**Technical News 163**  
**April 2015**  
**Strictly Confidential**

**Contents**

**Description:** Mudguard Alignment

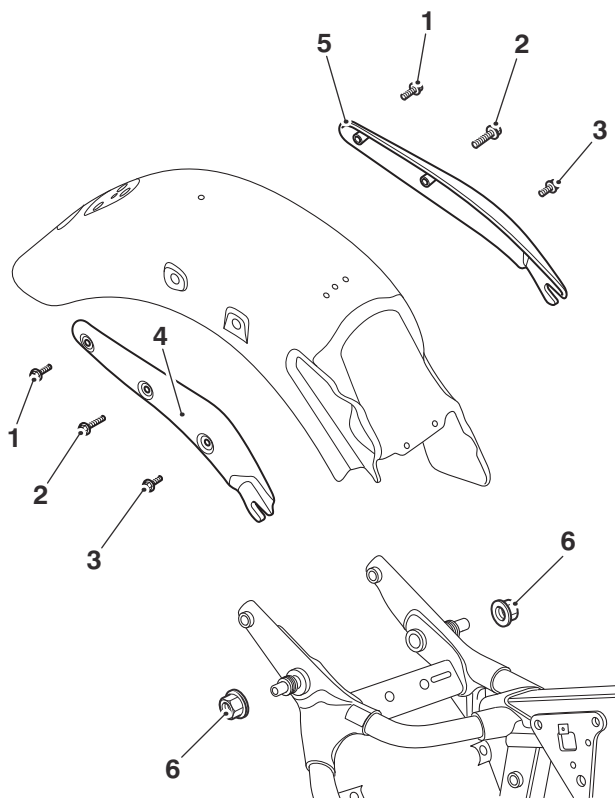
In the event that the rear mudguard alignment on the above models requires adjustment, proceed as follows:

1. Apply pressure downwards to left hand side mudguard bracket and left hand side of mudguard.
2. Tighten rear suspension unit boss to bracket nut (left hand side) to **108 Nm**.
3. Tighten mudguard bracket to frame fixing (left hand side) to **60 Nm**.
4. Tighten front mudguard to bracket fixing (left hand side) to **25 Nm**.
5. Tighten rear mudguard to bracket fixing (left hand side) to **25 Nm**.

6. Apply pressure upwards to right hand side mudguard bracket and right hand side of mudguard.
7. Tighten rear suspension unit boss to bracket nut (right hand side) to **108 Nm**.
8. Tighten mudguard bracket to frame fixing (right hand side) to **60 Nm**.
9. Tighten front mudguard to bracket fixing (right hand side) to **25 Nm**.
10. Tighten rear mudguard to bracket fixing (right hand side) to **25 Nm**.

1. Apply pressure downwards to right hand side mudguard bracket and right hand side of mudguard.
2. Tighten rear suspension unit boss to bracket nut (right hand side) to **108 Nm**.
3. Tighten mudguard bracket to frame fixing (right hand side) to **60 Nm**.
4. Tighten front mudguard to bracket fixing (right hand side) to **25 Nm**.
5. Tighten rear mudguard to bracket fixing (right hand side) to **25 Nm**.

6. Apply pressure upwards to left hand side mudguard bracket and left hand side of mudguard.
7. Tighten rear suspension unit boss to bracket nut (left hand side) to **108 Nm**.
8. Tighten mudguard bracket to frame fixing (left hand side) to **60 Nm**.
9. Tighten front mudguard to bracket fixing (left hand side) to **25 Nm**.
10. Tighten rear mudguard to bracket fixing (left hand side) to **25 Nm**.

**Description:** Sump

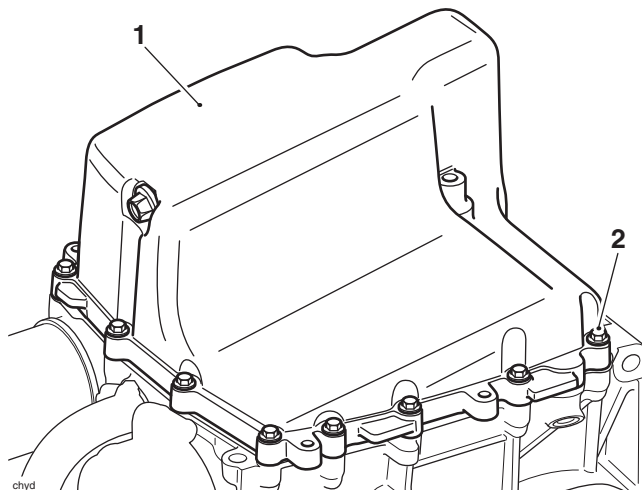
The torque figure for the sump fixings has changed to **10 Nm** on the above models.

- **Models already in service need not be retightened unless the fixings have been loosened or removed.**

**Description:** Crankcase Breather Cover Bolts

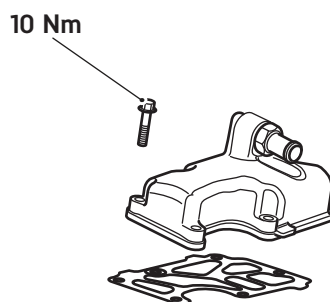
The torque figure for the crankcase breather cover bolts has changed to **10 Nm** on the above models.

- **Models already in service need not be retightened unless the fixings have been loosened or removed.**

**Description:** Seat Lock

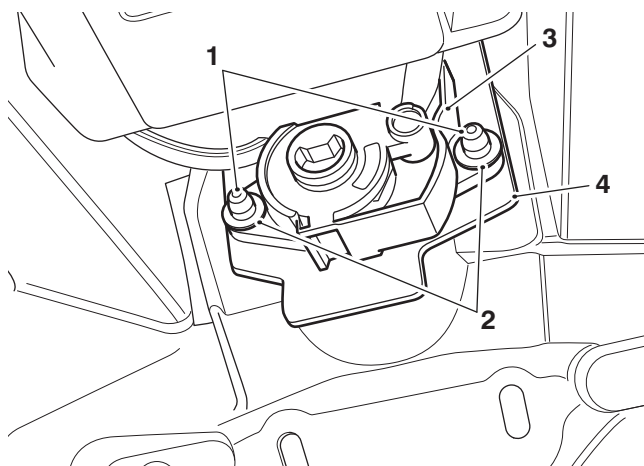
A revised washer has been introduced on the above models from VIN 708953 and is retrofittable. The thicker washer allows the rivet to achieve a tighter fixing between the seat lock and its bracket. If the seat lock is removed or replaced for any reason, one thicker 11 x 1.6 mm washer is to be used with a new 4.8 x 18 mm rivet.

- Models already in service need not be replaced unless the seat lock has been loosened or removed.

**Description:** Reflector Mounting O-Rings

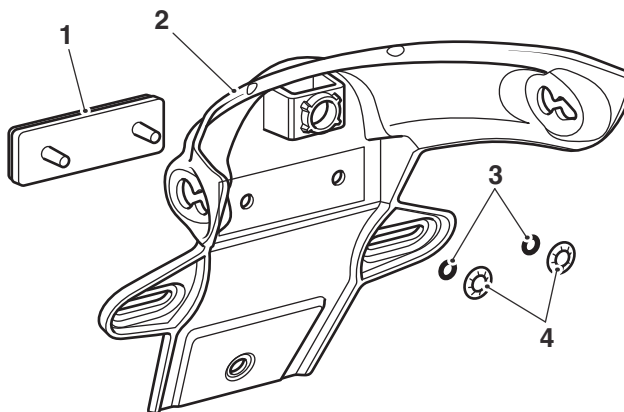
O-rings have been introduced to the rear reflector mountings on the above models from VIN 702714.

The new O-rings are retrofittable to the above models.

1. Position the rear reflector to the registration plate moulding and secure using the rubber O-rings and the retaining washers as shown below.

**Description:** Water Inlet Cover Bolt and Water Outlet Cover Bolts

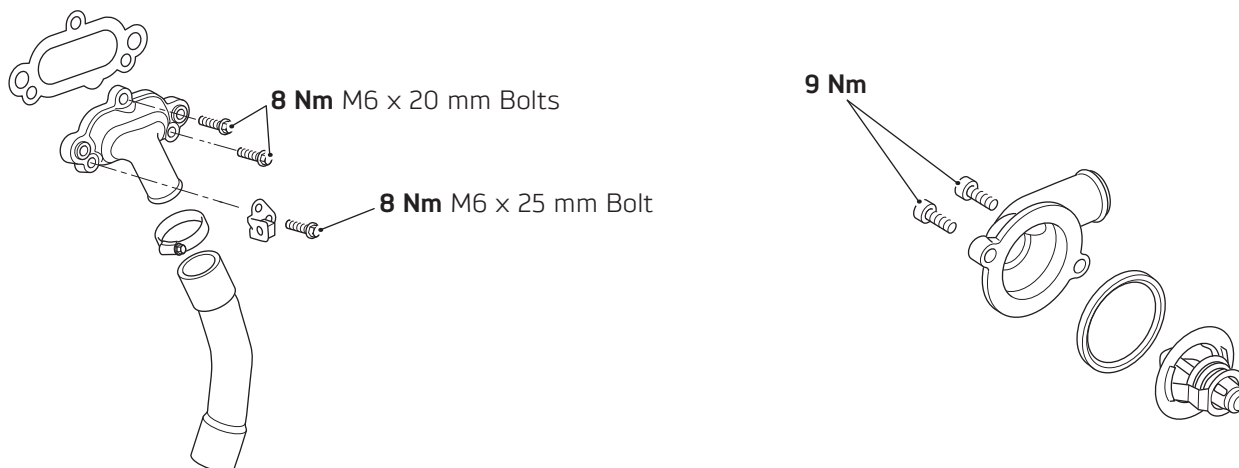
The torque figure for the M6 x 1.0 mm x 25 mm water inlet cover bolt has changed to **8 Nm** on the above models. The torque figure of **8 Nm** is unchanged for the remaining two M6 x 1.0 mm x 20 mm water inlet cover bolts.

The torque figure for the water outlet cover bolts has also changed to **9 Nm**.

- **Models already in service need not be retightened unless the fixings have been loosened or removed.**
